Title:	MCC HVAC Upgrades			
Number:	SB_588.4	Release Date:	6/20/2022	
Revision Number:	4	Revision Date:	7/25/2023	
Chassis Type:	Velocity, Impel, Enforcer			
Component Description:	MCC HVAC SYSTEM			
Warranty:	N/A			
Parts:	N/A			
Tools:	N/A

Addressing fault codes and upgrades to the Midwest Climate Control (MCC) HVAC system.

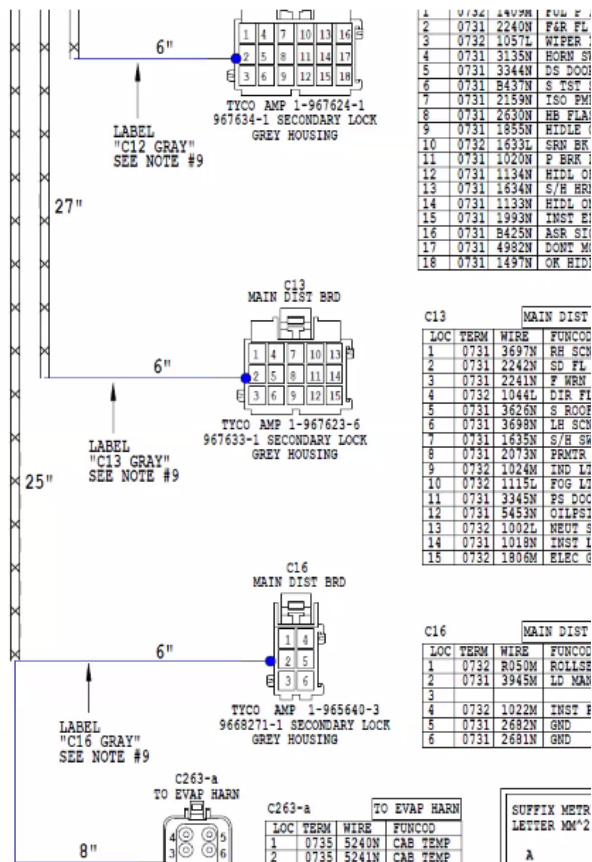
4. If vehicle is hardwired (not using multiplex networking) re-pin load manager connector to control panel part number # **63-4753-0002**.

- a. With the correct Mini-Fit Junior pinning tool, re-pin wire 3495 in connector C184 from pin 16 to pin 14.
- b. If the correct Mini-Fit Junior pinning tool is not available:
 - i. Cut wire 3495 at connector C184.
 - ii. Connect wire 3495 to wire 4562 at connector C309.
 - iii. Leave wire 4562 in connector C184 pin 14.
- c. Refer to diagram below:
